DMC:	342-49-035 – SERVICE BULLETIN
Title:	Introduction of an APU Fuel Leak Check
Issue number:	001
Issue Date:	17-12-2020

Applicability: In-service APUs with more than 3,000 cycles and equipped with at least one fuel line P/N 942006 (pre SB 342-49-026 configuration)

This Service Bulletin introduces the procedure "Fuel Leak Check" and the procedure to be performed when a fuel leak is confirmed (replacement of the five fuel lines of the main burners manifold).

Figure 1: Identification of areas where the application of an absorbent is recommended

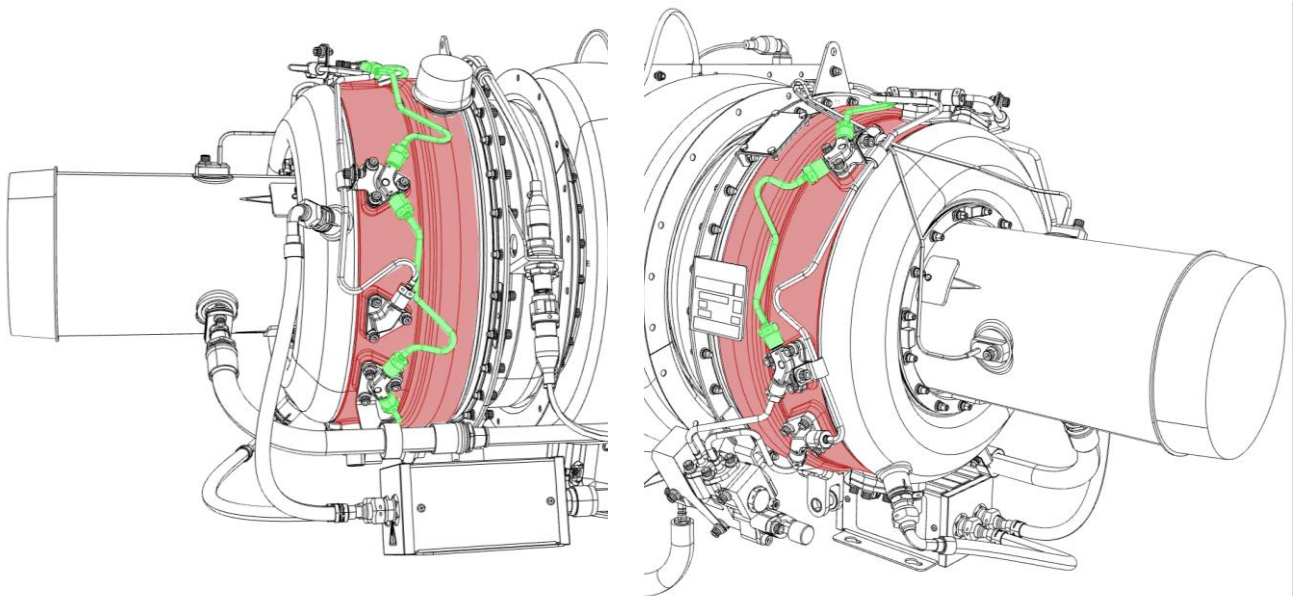
1. If the APU is installed in the helicopter, open the APU access doors 461A, 462A, 463A and 481A.
2. Clean the main burners manifold and the combustion casing with a cloth.
3. Apply an absorbent (e.g. talcum) over the main burners manifold and the combustion casing (see colored areas in Figure 1).

6. If the APU is installed in the helicopter, open the APU access doors 461A, 462A, 463A and 481A.
7. Inspect each pipe of the main burners manifold (in green on Figure 1) for fuel leaks.
8. If fuel leak is detected:
 - 8.1. Inform Safran Power Units (refer to para. 3.5.2).
 - 8.2. Replace the five fuel lines of the main burners manifold as per the instructions of the DMC 89-A-49-31-05-00A-520A-B and 89-A-49-31-05-00A-720A-B.

Figure 2: Location of the detected fuel leak

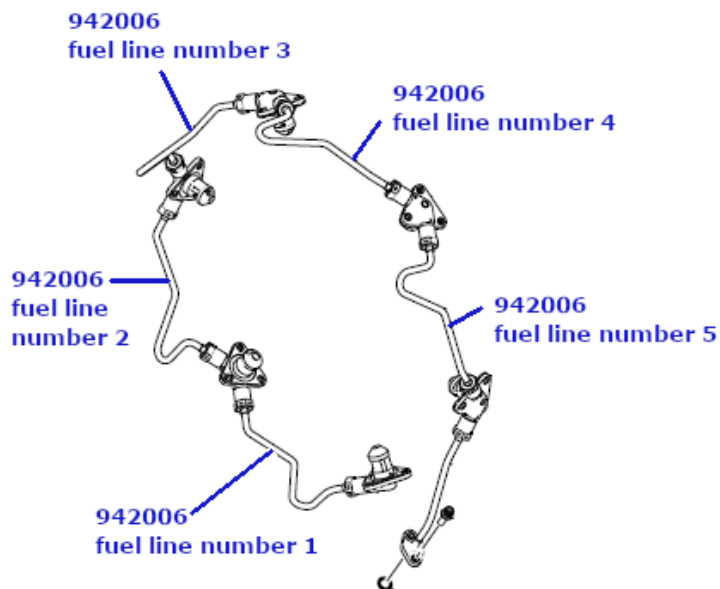
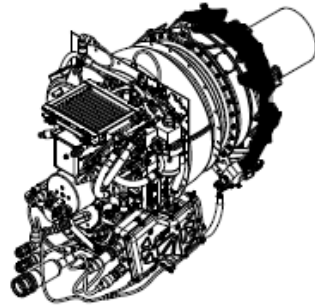
- Location of the leak (used the figure below and the fuel line number),
- Picture and/or video of the detected leak,
- Detail description of the finding,
- Specify if the fuel lines have been replaced due to the presence of the fuel leak.
